SERVICE LETTER

SUBJECT: Possible damage to turtle deck.

-Figure 1-

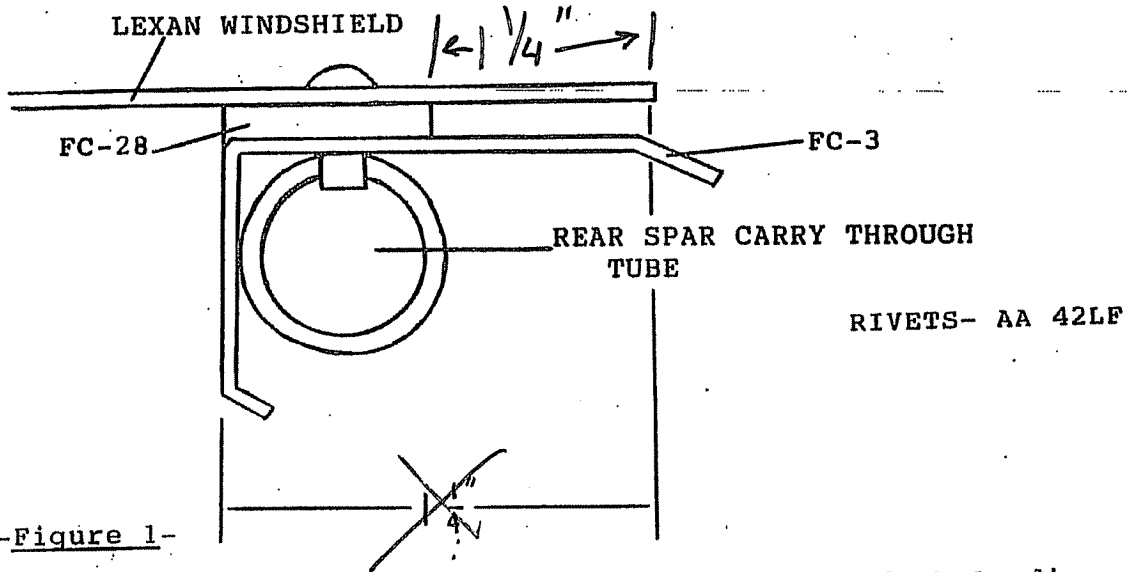
EXPLANATION: It has come to our attention that some builders are not providing adequate edge distance at the rear most edge of the Lexan skylight. The leading edge of the turtle deck must engage the skylight with a minimum overlap of 1 1/4".

ACTION: If you have not yet installed your skylight, refer to figure 1. Note, the edge distance on the skylight must be at least 1 1/4".

To ensure proper engagement of the turtle deck leading edge under the Lexan skylight, see that a minimum of 1 1/4" of skylight extends off as measured from the ~~front edge~~ **BACK EDGE** of FC-3 to the rear edge of the Lexan. **OF FC-28**

I MARKED THIS UP PER THE EXPLANATION ON THE SERVICE LETTER. I HAVE SEEN MANY TIMES WHERE THE ILLUSTRATOR DOES NOT PROPERLY DRAW WHAT SHOULD BE SHOWN... JUST MY SNAKE OIL BUT I SLIP THE CRAP OUTA MY PLANE WITH 1 1/4" OVERLAP AND HAVE NEVER TOPPED THE DECK OFF.

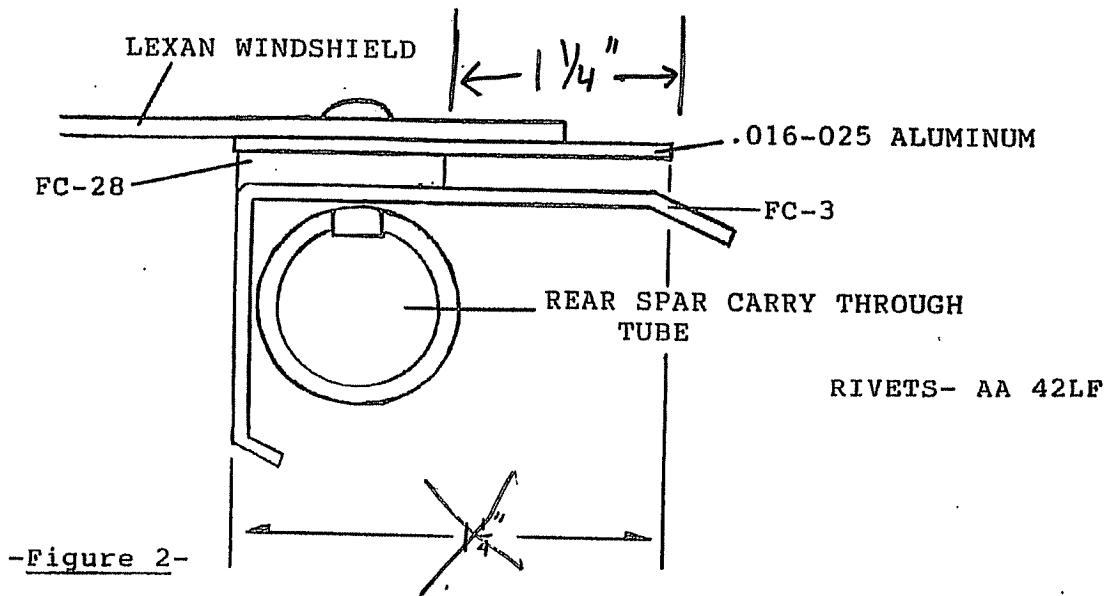
If your skylight has been installed, check to see that the minimum edge distance requirement has been met. If after inspection it is determined that you have inadequate edge distance, refer to Figure 2.

- A. Remove rivets attaching the Lexan to the rear spar carry through tube.
- B. Install an aluminum strip .016-025-thick, between PN FC-28 and the Lexan windshield ensuring a minimum of 1 1/4" length as measured ~~from the front edge of FC 3 to the rear most edge of the aluminum strip.~~
- C. Install rivets, check turtle deck fit.
